# INDIANA RESIDENTIAL CODE

2005 EDITION  
675 IAC 14-4.3

*Amended and effective on September 11, 2005*

## Rule 4.3. Indiana Residential Code

FIGURE R502.8  
CUTTING, NOTCHING AND DRILLING

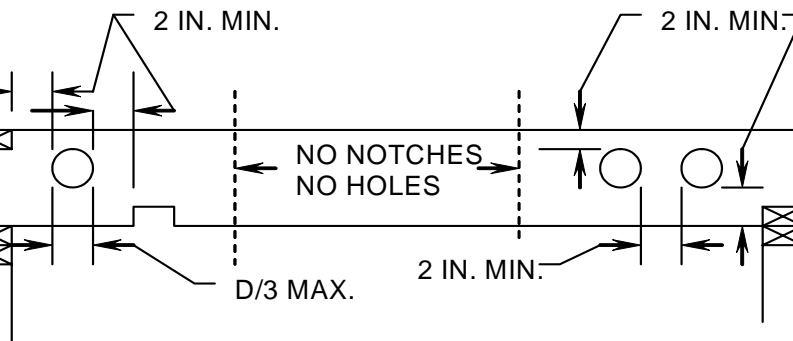
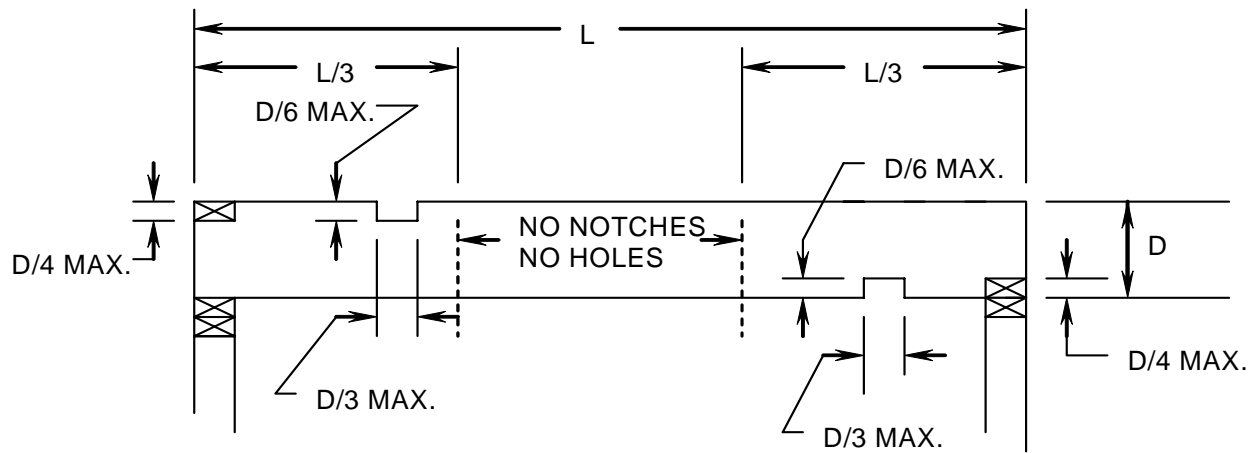
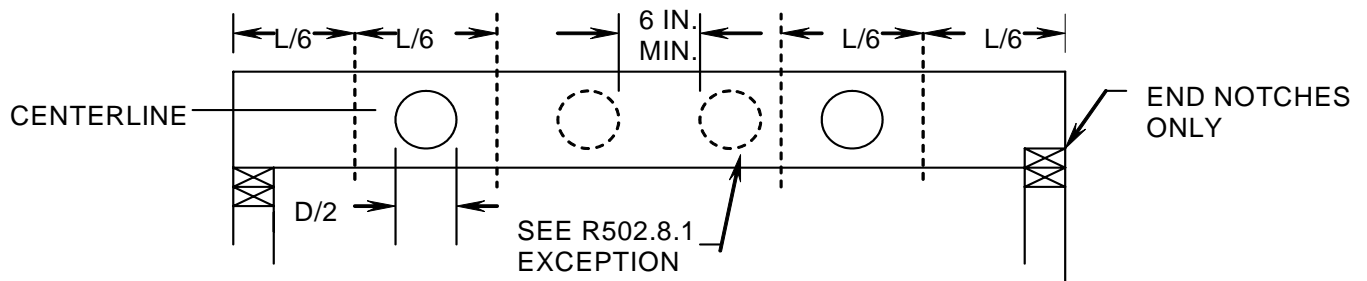
Sec. 88. Delete FIGURE R502.8 and substitute as follows: FIGURE R502.8:

FIGURE R602.6(2)  
NOTCHING AND BORED HOLE LIMITATIONS FOR INTERIOR NONBEARING WALLS  
(675 IAC 14-4.3-95) Eff. September 11, 2005

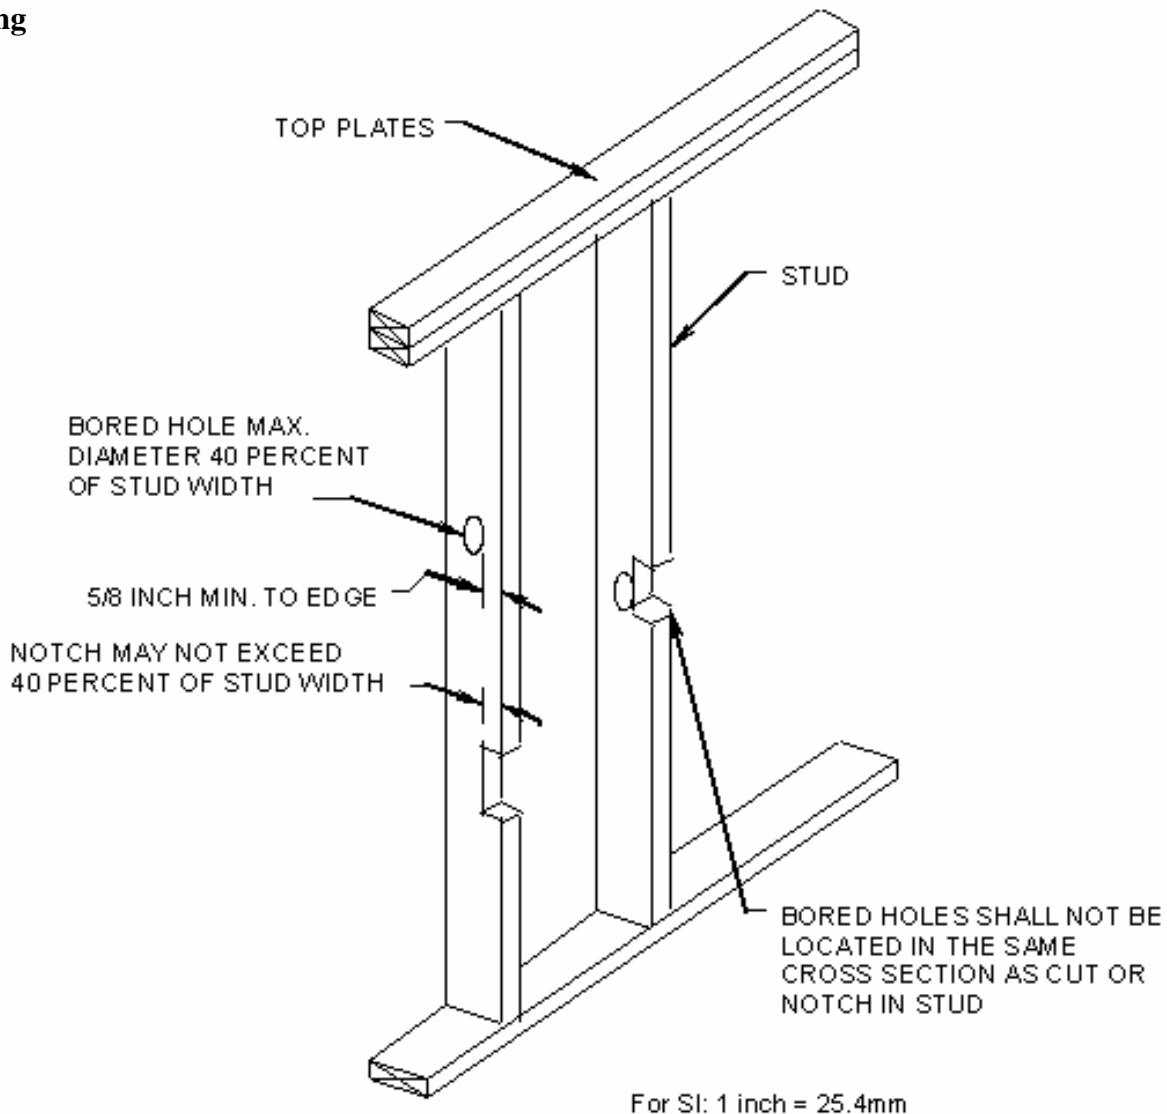
Sec. 95. Delete FIGURE R602.6(2) and insert FIGURE R602.6(2) to read as follows:

FIGURE R602.10.5(2)  
GARAGE DOOR BRACED WALL PANEL FOR USE WITH CONTINUOUSLY SHEATHED WALLS

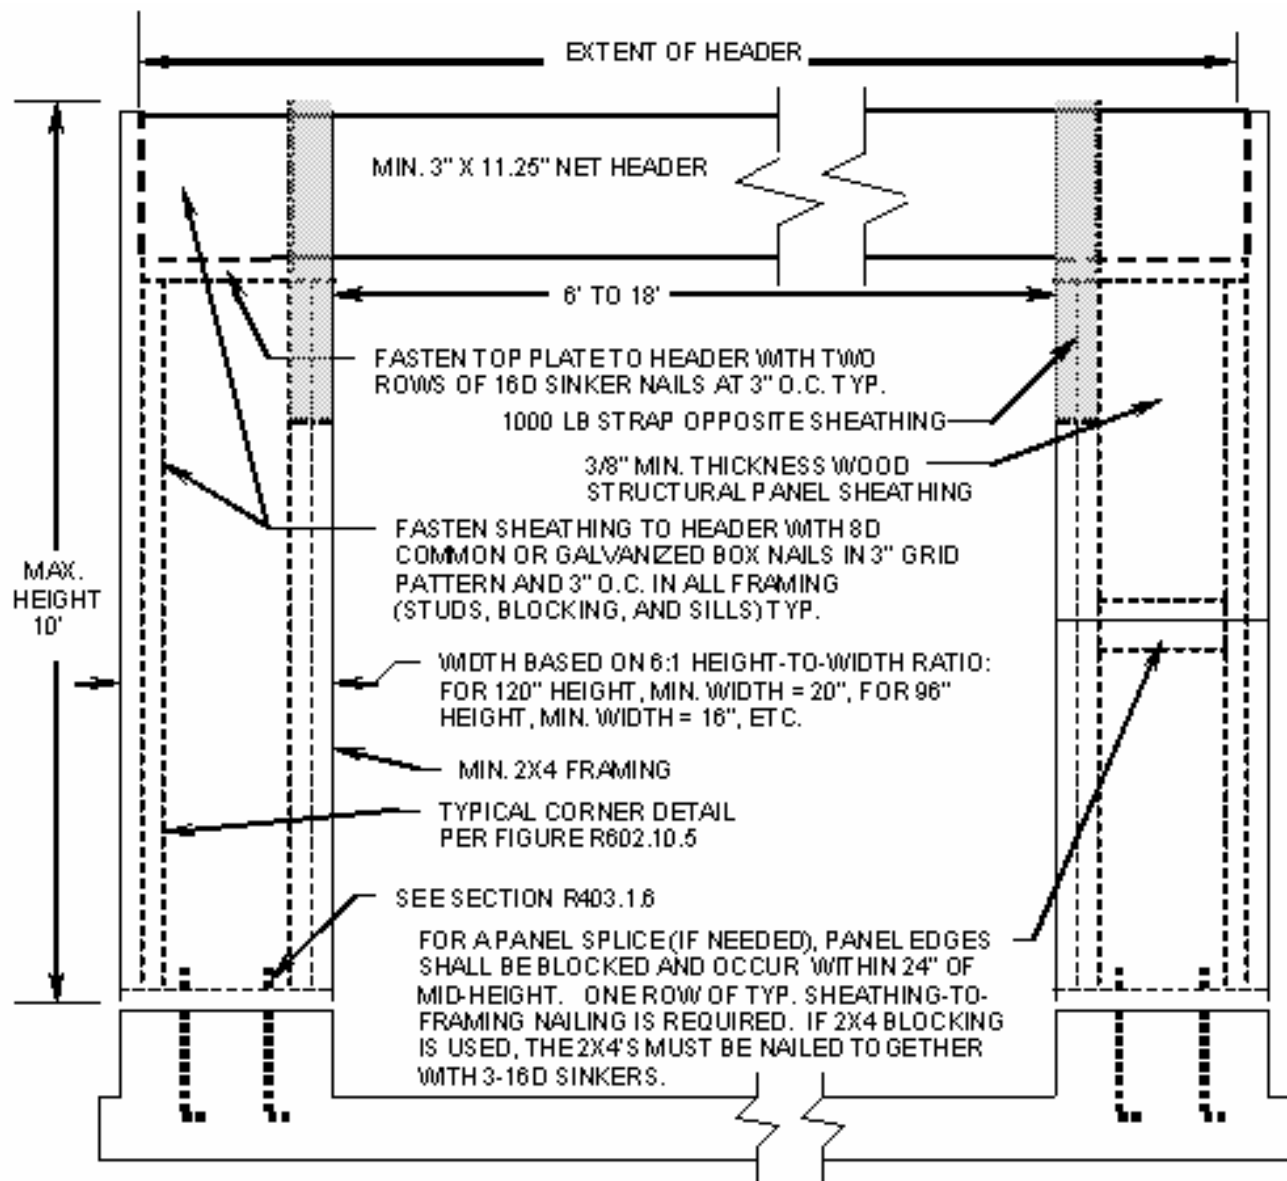
(c) Add Figure R602.10.5(2) to read as follows:

**FIGURE R703.7.6(1)**

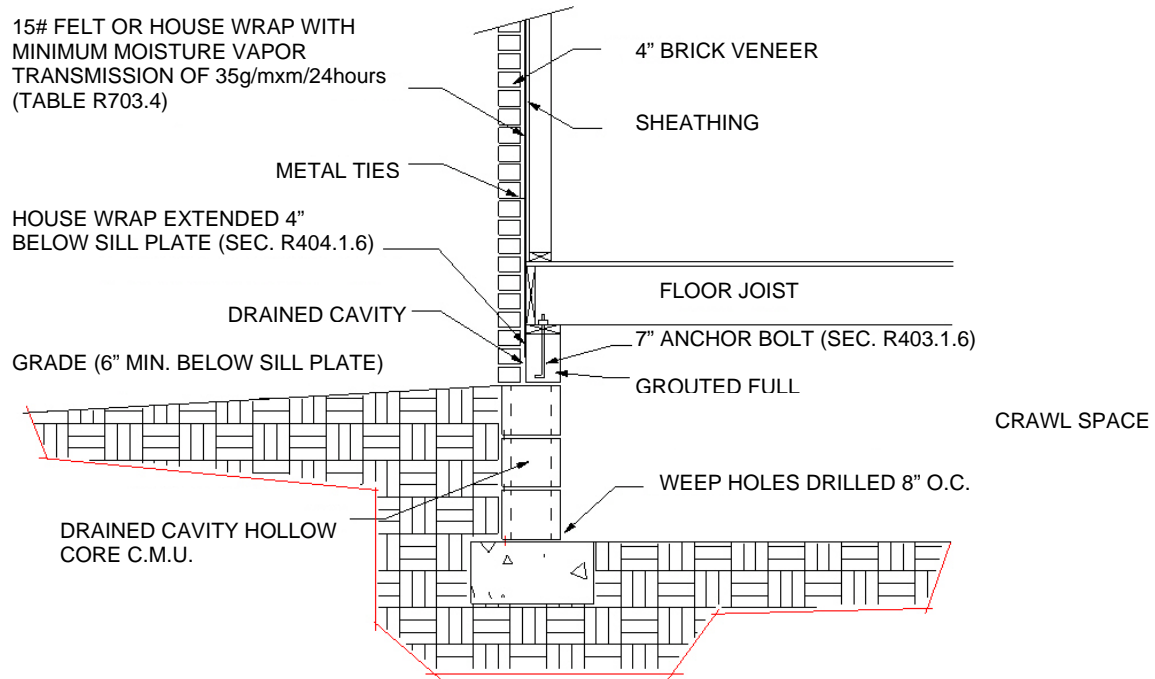
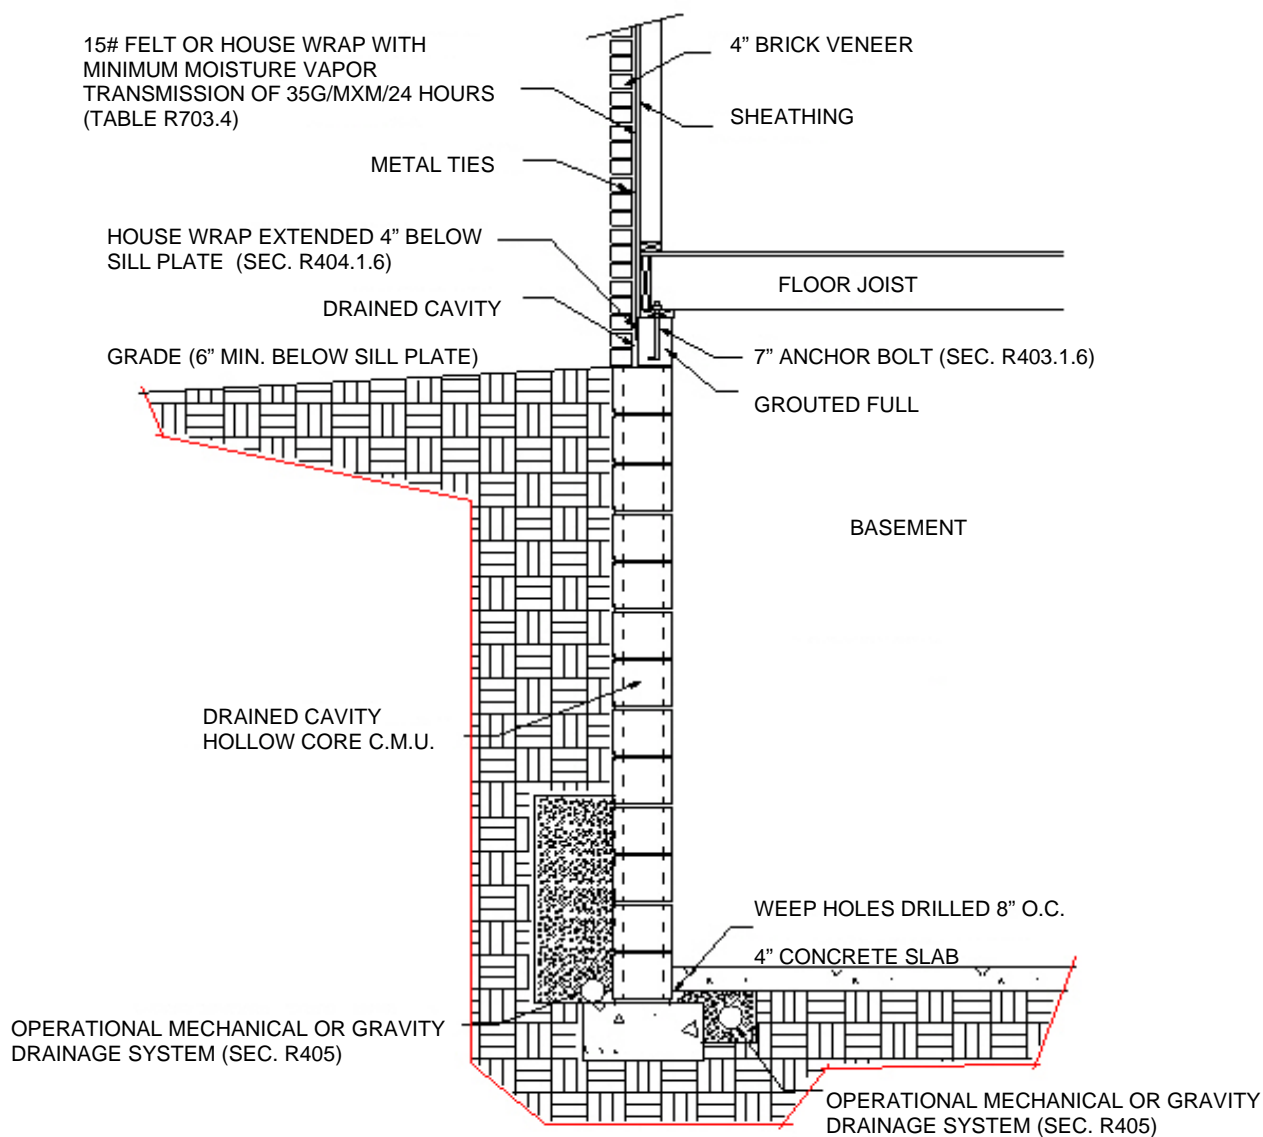
Sec. 121. Delete the title and text of SECTION R703.7.6 and substitute as follows: R703.7.6 Drained cavity. The 3/4 inch (19 mm) air cavity shall be drained to the exterior of the structure at intervals of not more than 33 inches (838 mm) on center. Each drain shall be not less than 3/16 inch (4.8 mm) in diameter, located immediately above the flashing. For dwellings with crawl spaces, the air cavity may be drained as shown in FIGURE R703.7.6(1). For dwellings with basements, the air cavity may be drained as shown in FIGURE R703.7.6(2). (675 IAC 14-4.3-121) Eff. September 11, 2005

## Figure R1001.6; termination

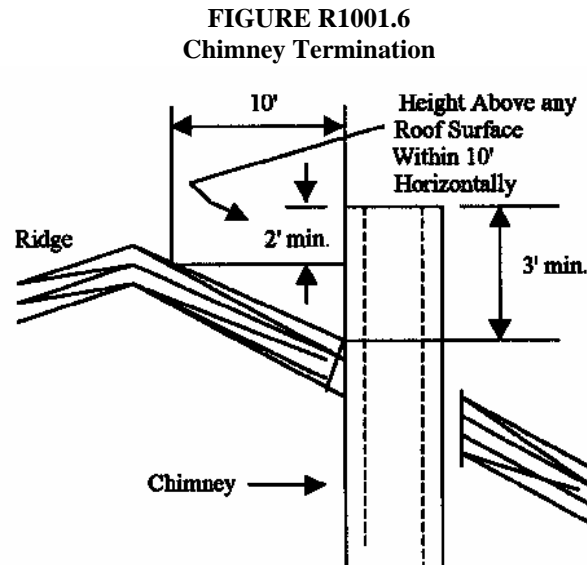
Sec. 135. Add FIGURE R1001.6 as follows:
